SECTION 00 9112 - ADDENDUM NUMBER 2

1.02 PROJECT: USC BARRINGER HOUSE MECHANICAL RENOVATION

1.03 OWNER'S PROJECT NUMBER: H27-Z335

3.10 DRAWING M2.0 - HVAC RENOVATION BASEMENT PLAN

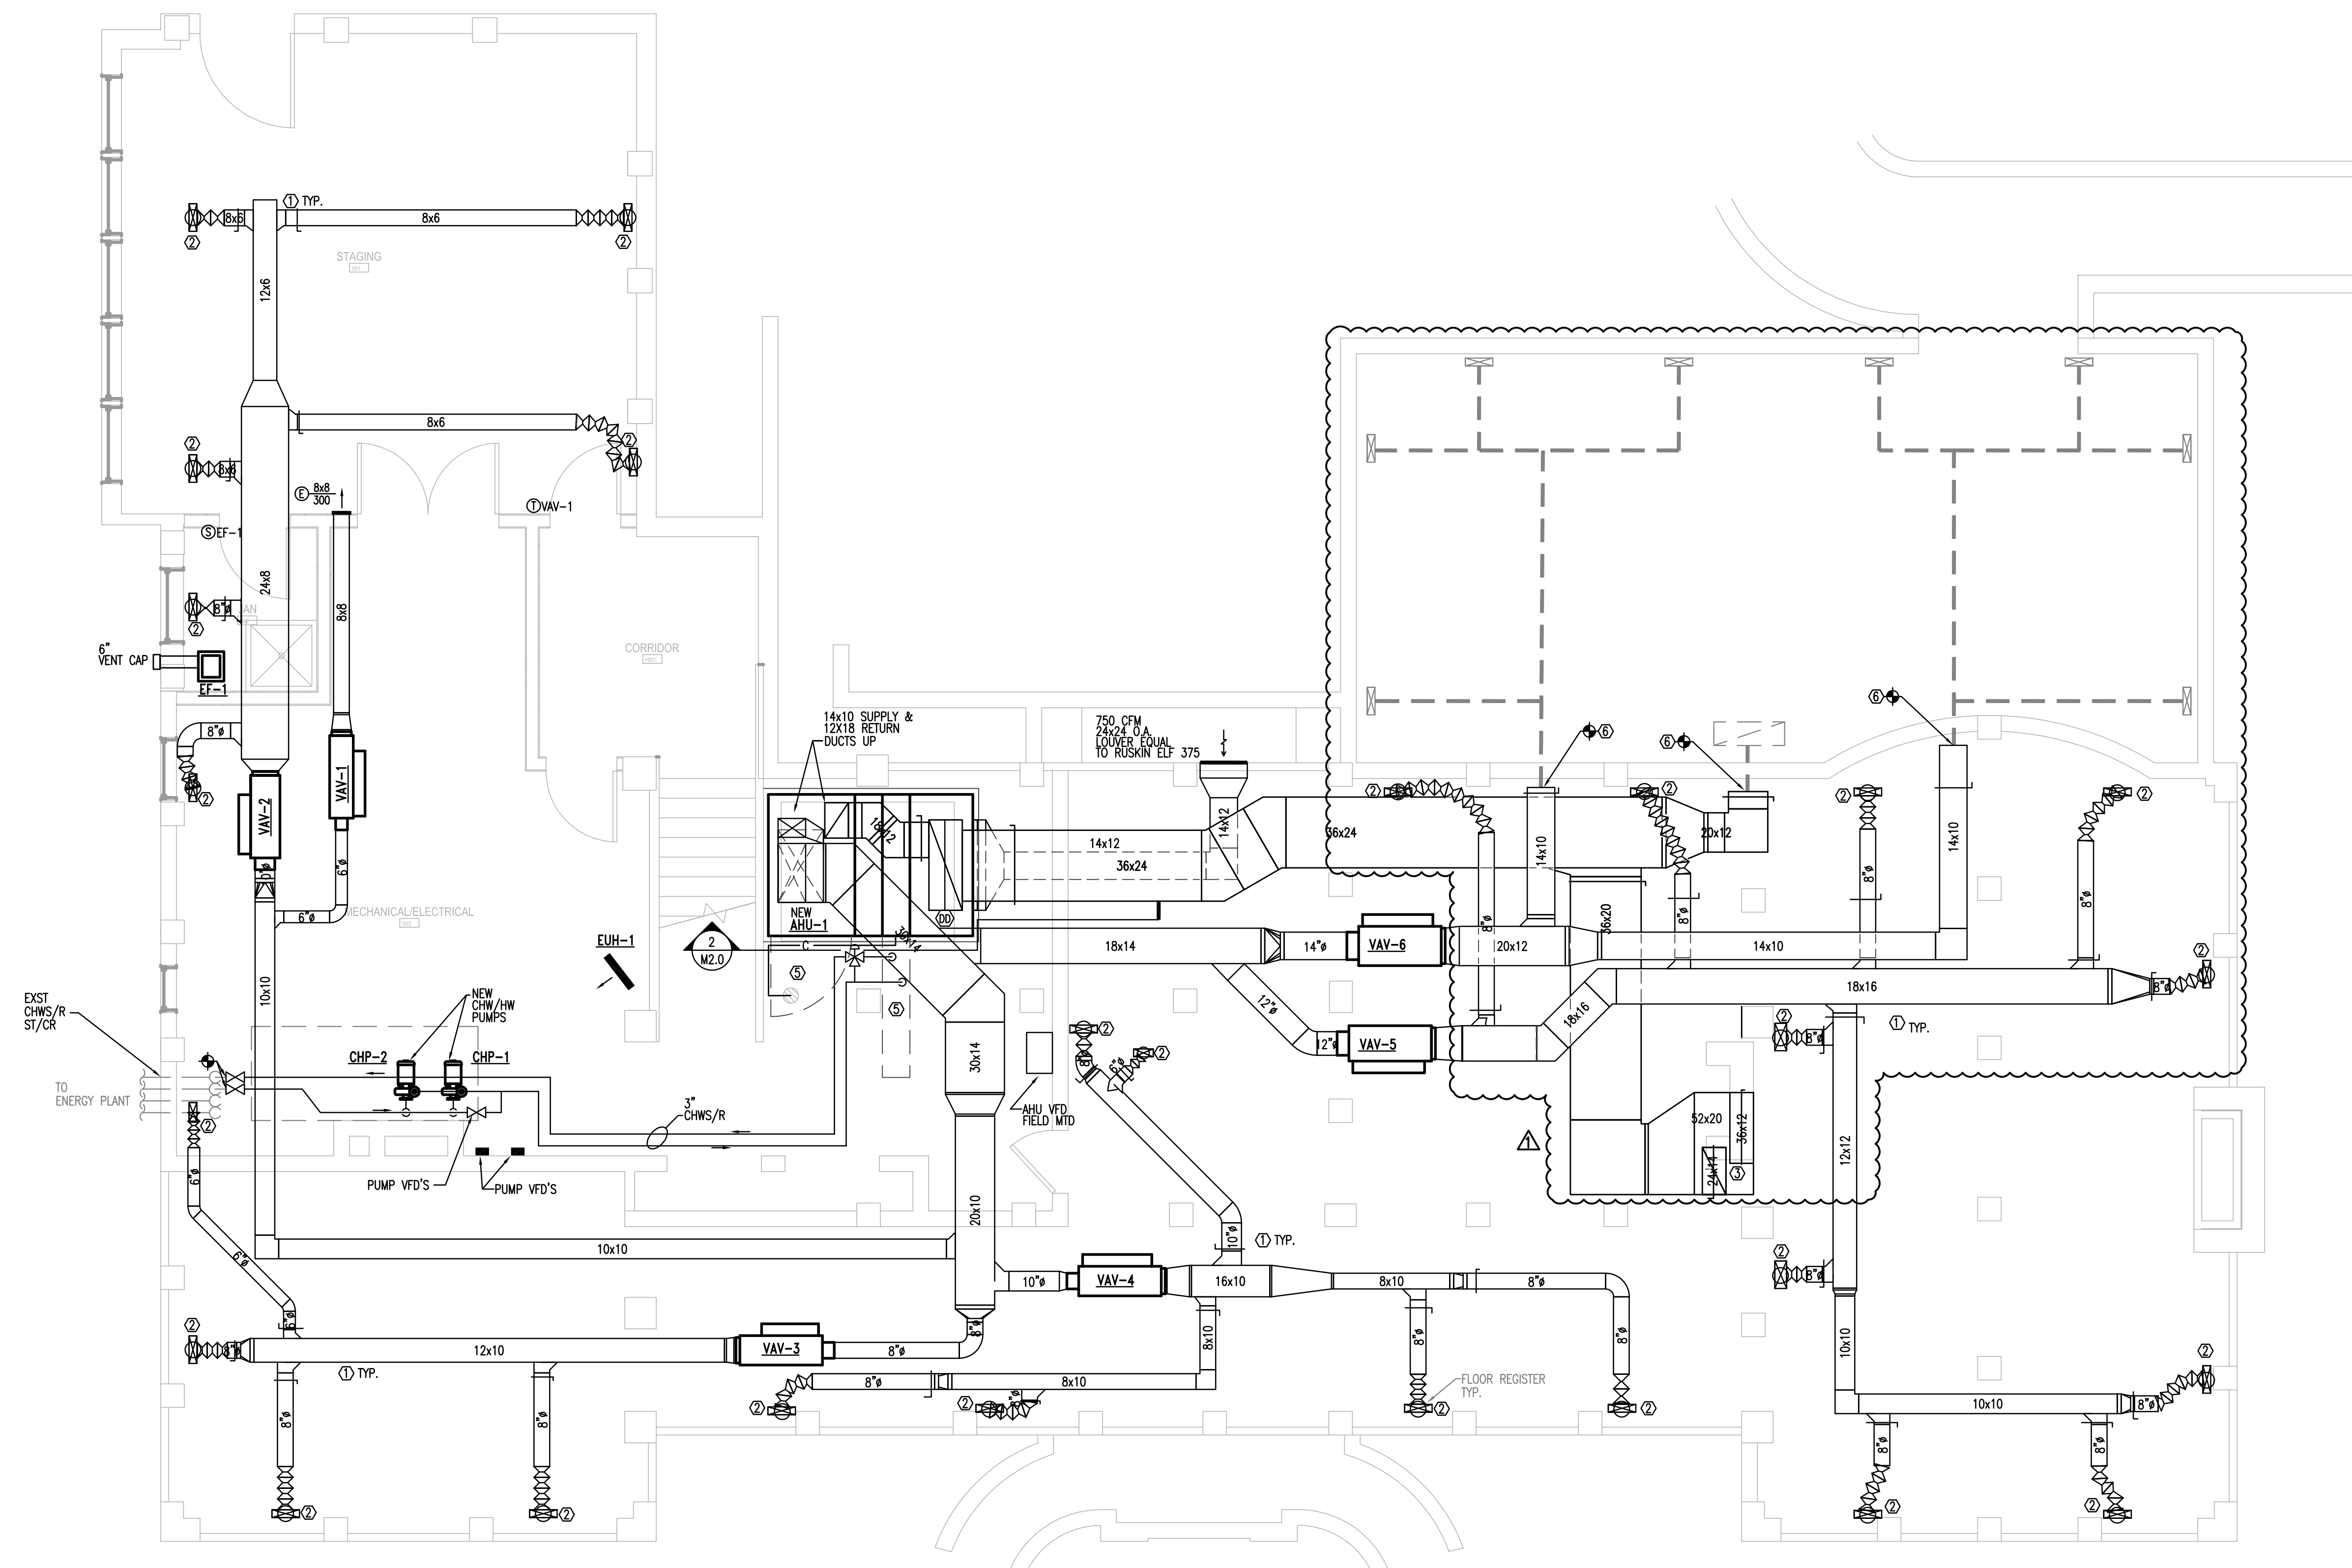
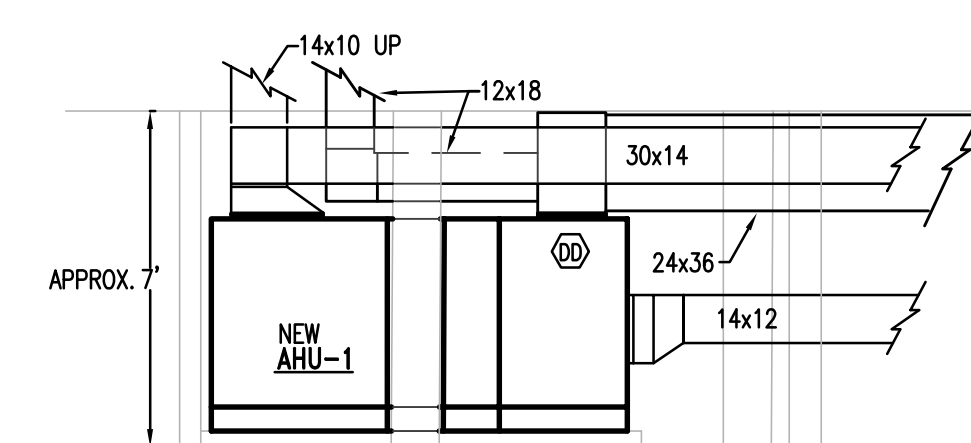
- A. Replace the existing drawing M2.0 in its entirety with the revised attached drawing M2.0.
 1. Revisions to the demolition, ductwork and diffusers are indicated.

sheet title
**HVAC
RENOVATION
SECOND FLOOR PLAN**

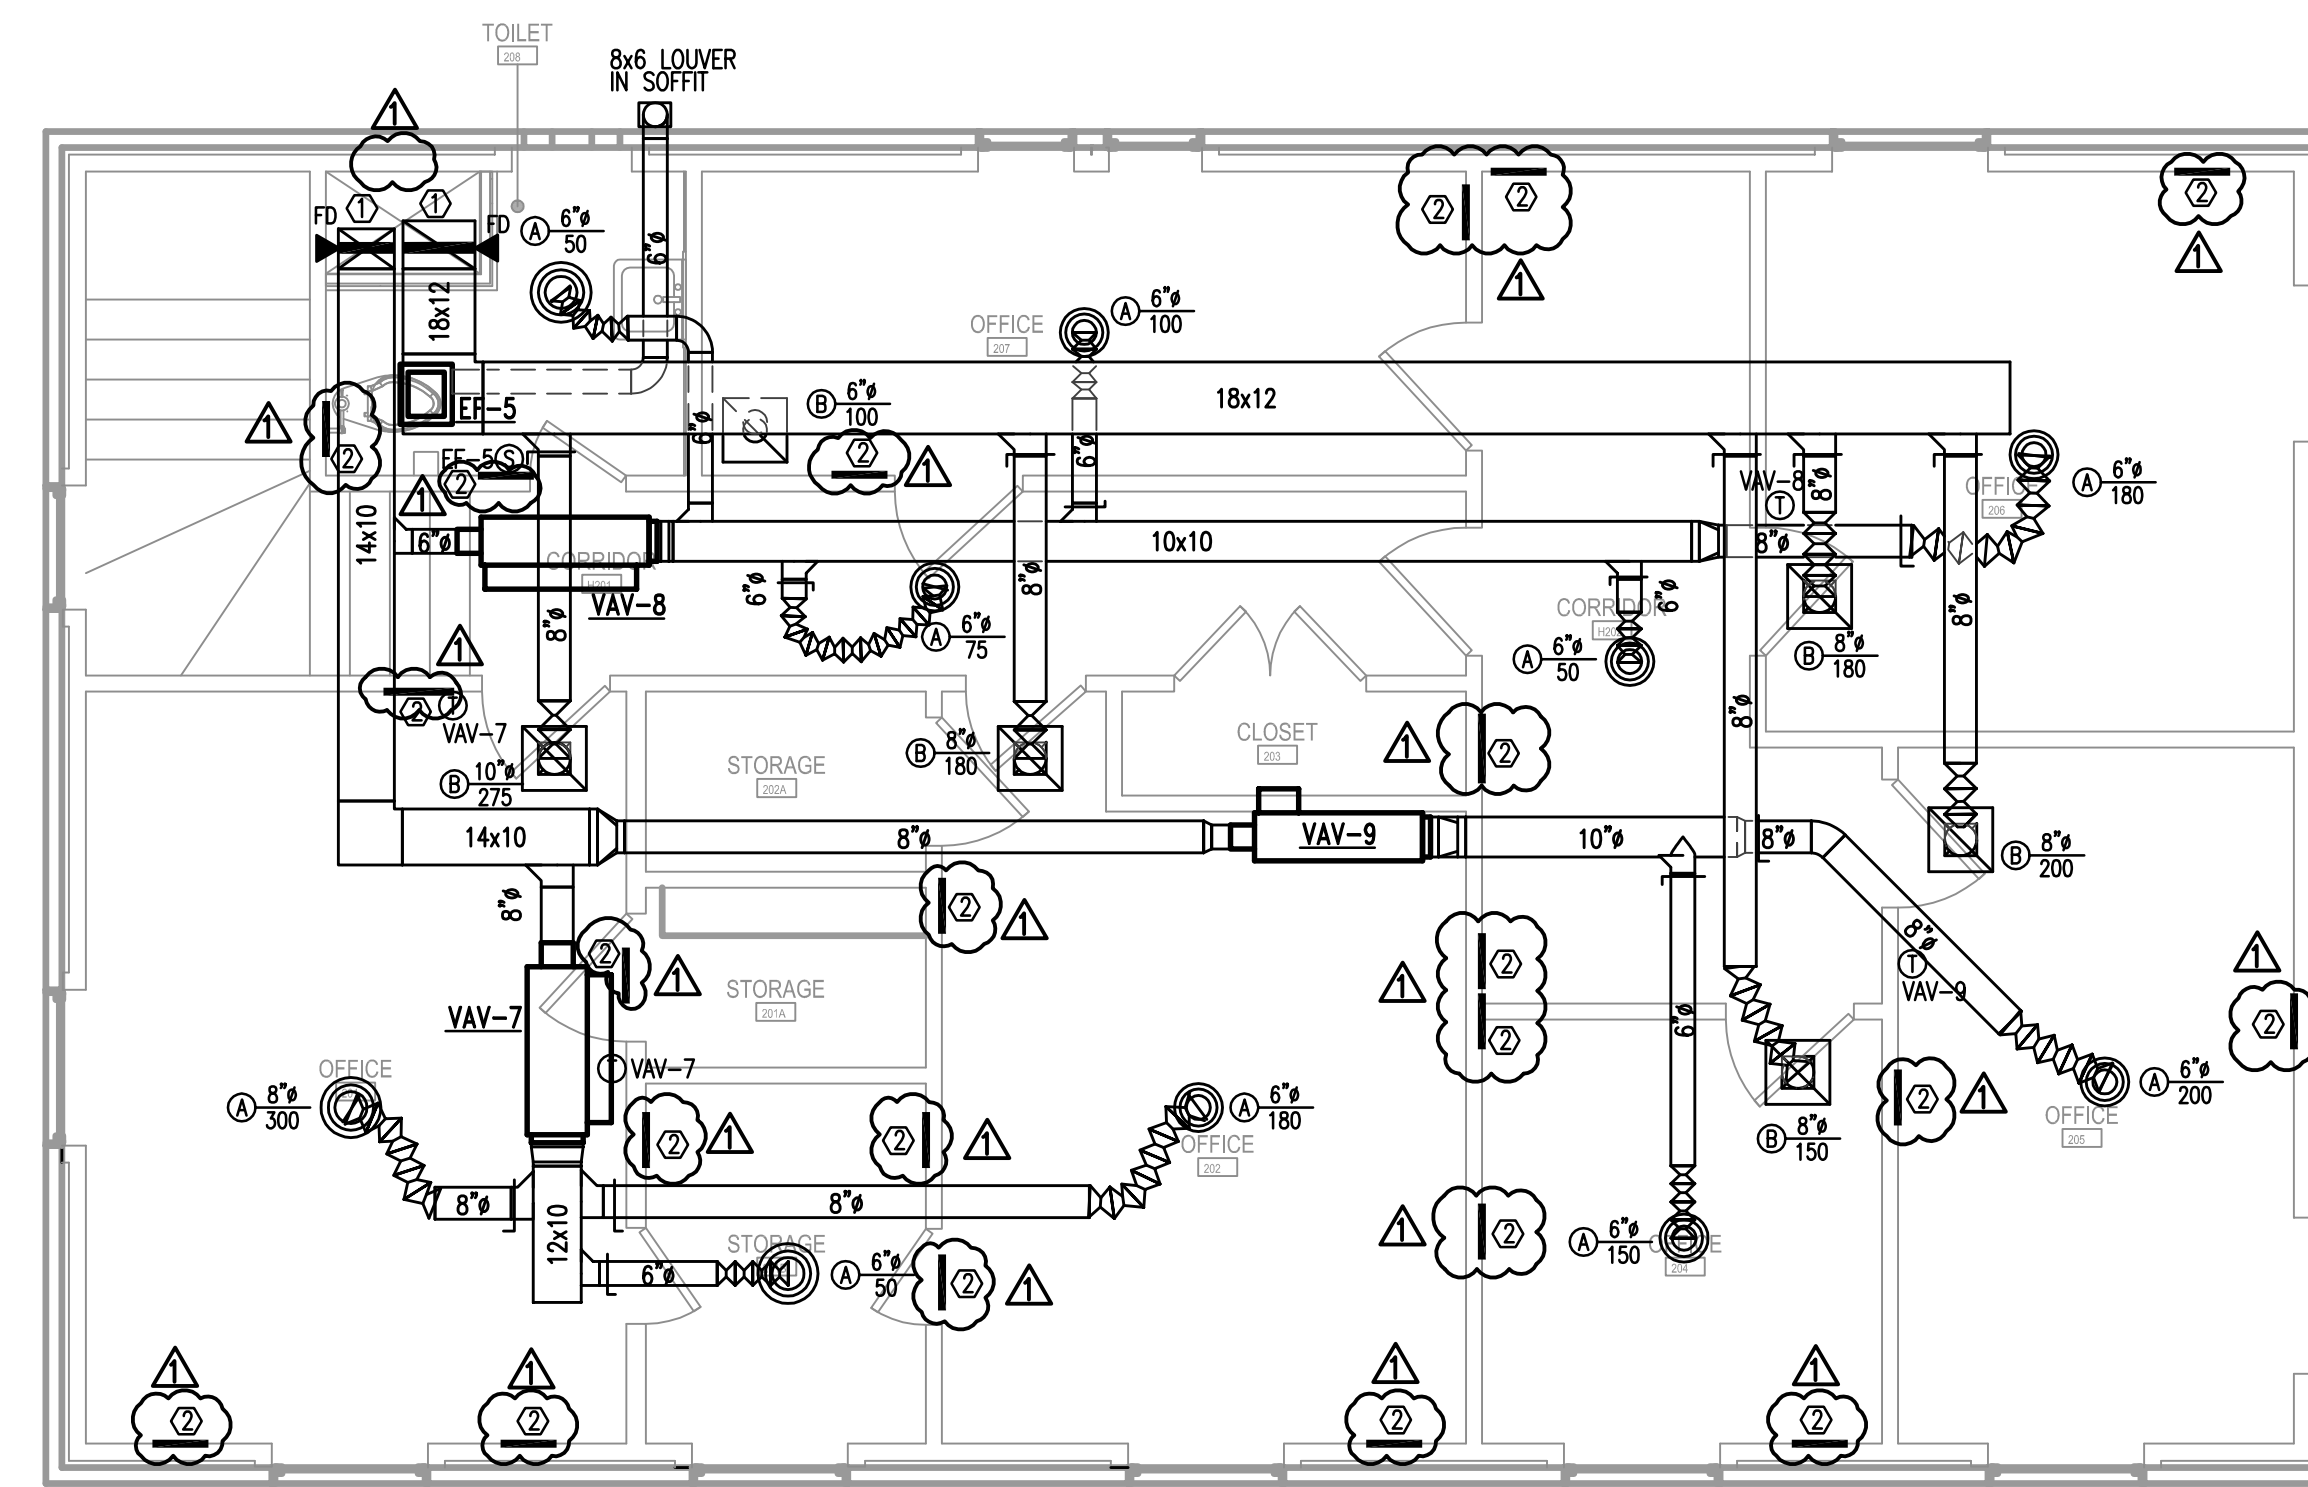
3.12 DRAWING M2.2 - HVAC RENOVATION SECOND FLOOR PLAN

- A. Replace the existing drawing M2.2 in its entirety with the revised attached drawing M2.2.
 1. Revisions to the demolition, ductwork and diffusers are indicated.
